Agenda Item # 9

AGENDA REPORT SUMMARY

Subject: Zoning Text Amendment ZTA 20-0003 to repeal and replace the design control sections of the Los Altos Municipal Code to codify objective zoning standards pursuant to recent changes to state law.

1. Objective Standards Ordinance
2. Objective Design Standards - clean version
3. Project Comments
4. Response to Comments

CD/R3 zone:

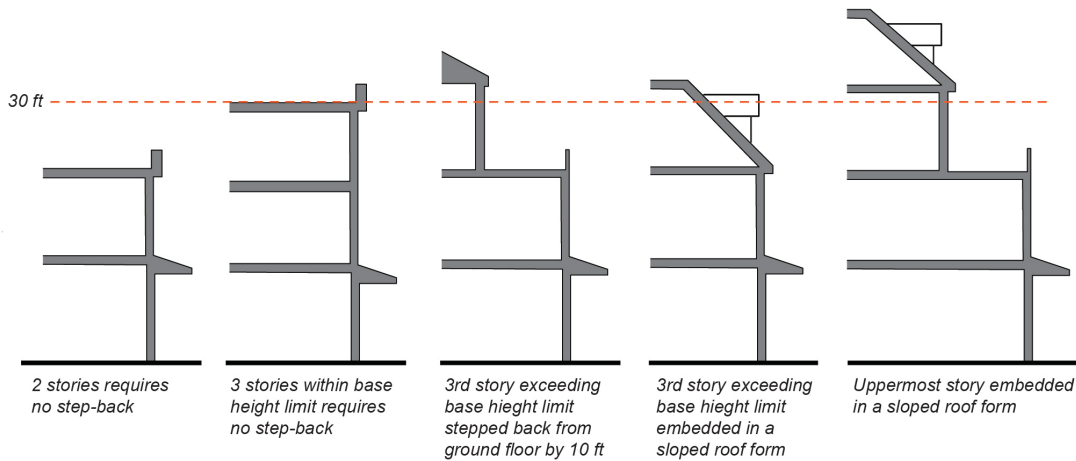
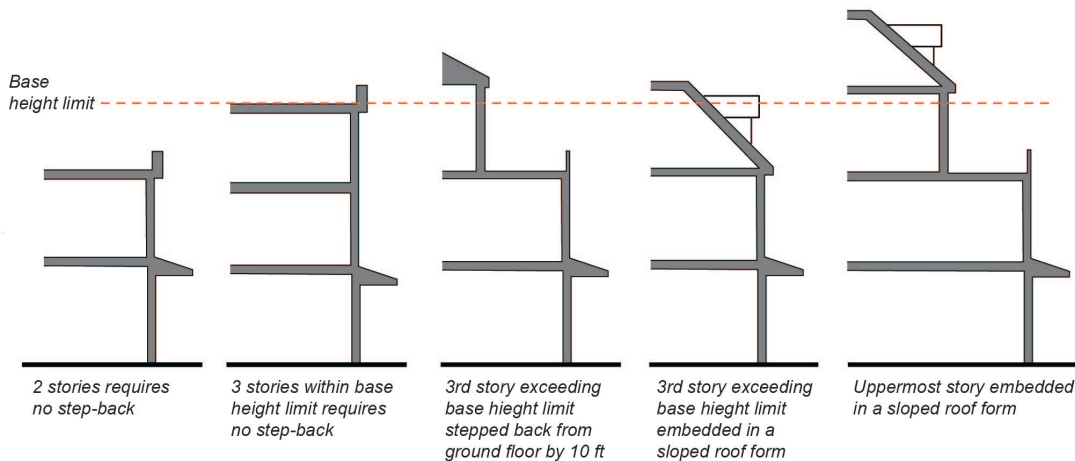
- b. If we stick with describing height in feet, then as CD/R3 is 30' for commercial or mixed use but 35' for all residential, it would be useful to add a dashed red line at 35' to the diagram
